SYDNEY CENTRAL CITY PLANNING PANEL COUNCIL ASSESSMENT REPORT

Panel Reference	PPSSCC-559
DA Number	DA/222/2024
LGA	City of Parramatta
Proposed Development	Staged Development comprising Stage 1 - Demolition of existing buildings, tree removal and construction of a part 4/part 7 storey residential flat building comprising 46 units and a shared basement carpark; Stage 2 - construction of a 6 storey mixed use development comprising an 80 place centre based child care centre and 45 residential units. A total of 22 residential units will be allocated for affordable housing in accordance with the requirements of the State Environmental Planning Policy (Housing) 2021.
Street Address	15A & 15B Moseley Street and 25, 27, 29 & 31 Donald Street, Carlingford, NSW, 2118
Applicant	The Trustee for Captag Investments Trust
Owner	Captag Investments Pty Ltd
Date of DA lodgement	22 April 2024
Number of Submissions	Four (4)
Recommendation	Refusal
Regional Development Criteria	Development with a capital investment value of more than \$30 million. (\$44,252,450)

Figure 3: Site Plan

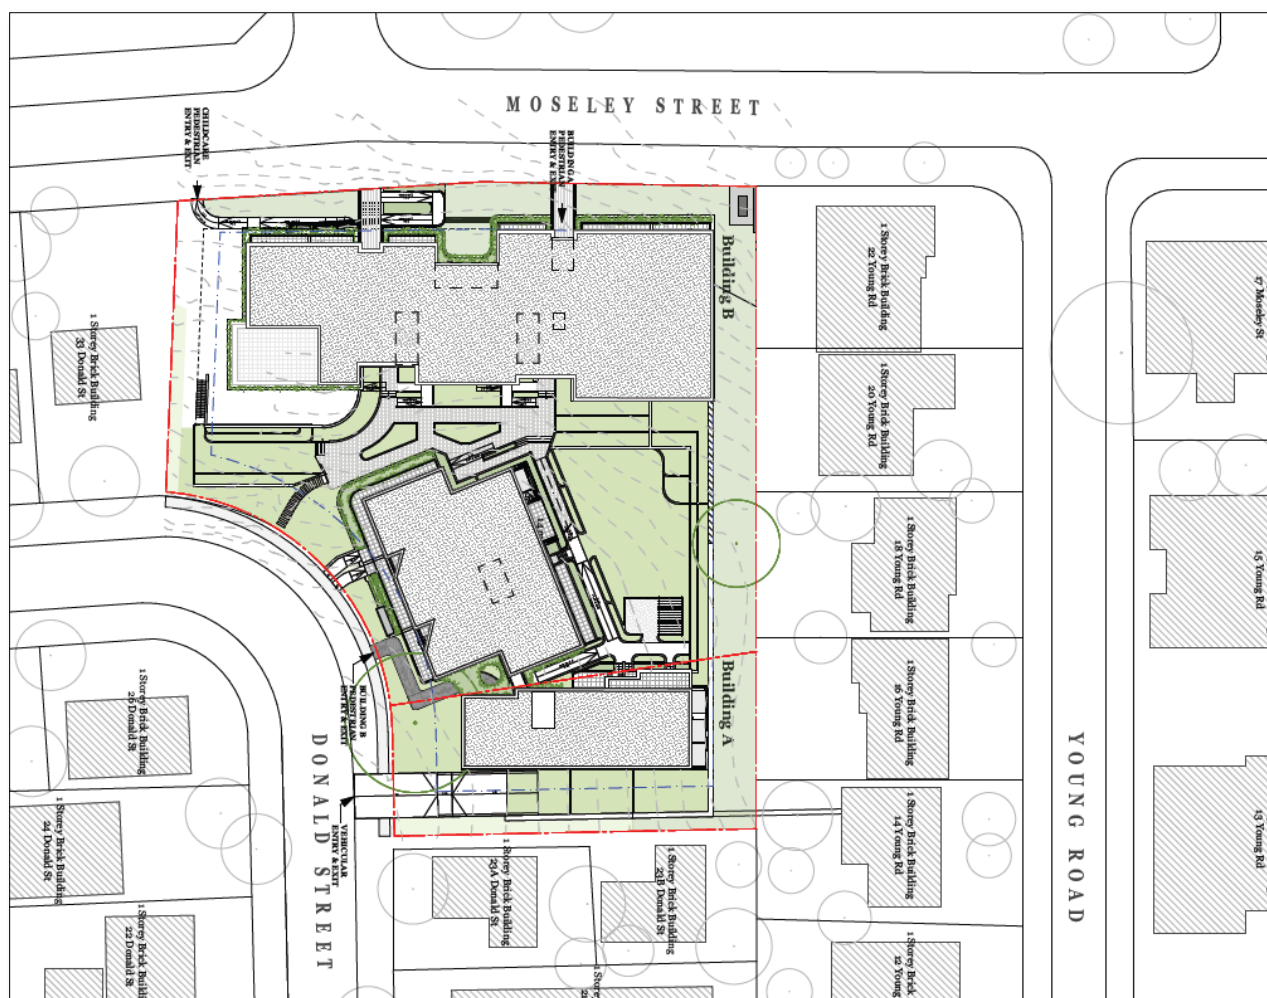
The issues with the proposal arise from the design of the development, primarily that the proposal comprises several variations and issues with respect to setbacks, landscaping, deep soil, communal open space, play areas of child care centre, stormwater drainage arrangements, tree removal/impacts. The proposal is considered an overdevelopment of the site, resulting in an excessive bulk and scale, along with concerns over inconsistency with the future character envisioned for the Carlingford Precinct. The development is out of character with the locality and results in the isolation of a property to the west of the site.

The site also has a long eastern boundary (which must transition to adjacent properties), a DCP required 10m Mosley Street front setback, a 6m Donald Street setback, solar access and overshadowing challenges and desired future character requirements as defined in PDGP 2023. However, apart from a very general analysis, the physical and planning constraints on the site appear not to have been examined or described sufficiently to support a series of legible design strategies – which again, appear too general to address the site's complexities.

- *The central communal open space is located on basement and is highly compromised by ramps, planters, walls and embankments; therefore its landscape quality, communal capacity, open space amenity and formal aesthetics are all highly compromised.*

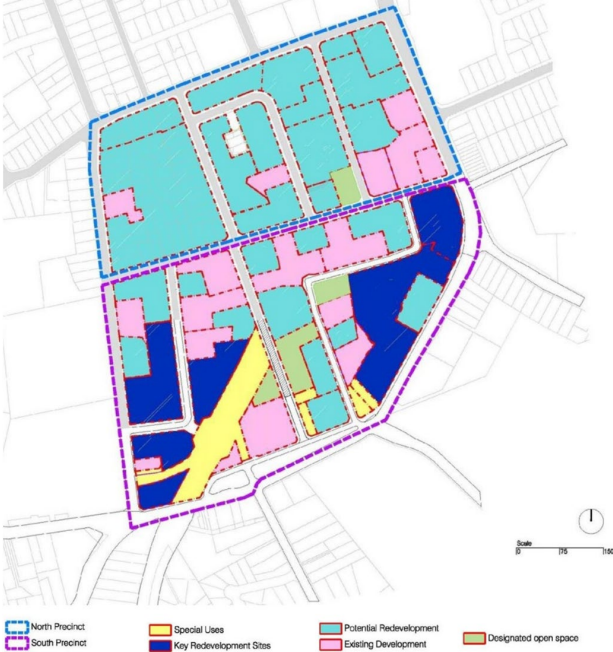
3.5.1.4 Open Space and Landscape		
<p><u>Deep Soil Zone</u></p> <p>Required: Min. 30% of the site (50% to be located at the rear)</p> <p>On sites over 1,500m², a min. dimension of 6m will be required for at least 7% of the total site area in accordance with the ADG.</p> <p>The remaining 23% of the deep soil zone may be provided with a minimum dimension of 4m x 4m.</p>	<p>Required: 1,784.4m² or 30%</p> <p>Proposed: 580m² or 9.7%. (with 6m dimensions)</p> <p>Clause 19 of the SEPP (Housing) 2021, prevents the consent authority from requiring more onerous standards for the matters listed under the clause. Therefore, as the SEPP (Housing) 2021 has precedence over the PDCP 2023, the deep soil requirements of the SEPP have been used for the deep soil calculations.</p> <p>It is noted that the subject site has an area of 5,948m² and would therefore require 6m dimensions for deep soil zone under the ADG.</p> <p>A deep soil area plan is submitted with the application which states that 1,381m² or 23% of the site is provided as</p>	No - See ADG discussion.

deep soil area however further details are required to demonstrate that it meets the required dimensions and depths. It appears that this 1,381m ² area does not meet min 6m dimensions area and that only 580m ² is provided. Further details would have been requested had the opportunity arose.	
<u>Basements</u> Where basements are provided and extend beyond the building envelope, a min. soil depth of 1.2m is to be provided, measured from the top of the slab, and will not be calculated as part of the deep soil zone.	Council's Landscape and Tree Management Officer has reviewed the application and notes that the soil depth and soil volume over structures (basement/OSD) appear to be inadequate and do not meet the requirements of the ADG. Council's Landscape and Tree Management Officer would have requested further information in this regard, had the opportunity arose.	No
<u>Communal Open Space</u> Residential flat buildings must provide communal open space to meet the requirements of Section 3D of the Apartment Design Guide.	The applicant has stated, and shown on a COS plan, that 1,612m ² of communal open space has been provided however it is considered that the communal open space, nominated for congregation and recreation, is limited and does not meet the area requirement, as a significant portion of the areas used in the calculation is convoluted and contains several stepped areas, retaining walls, pathways, etc that is not usable and/or accessible for activities.	No
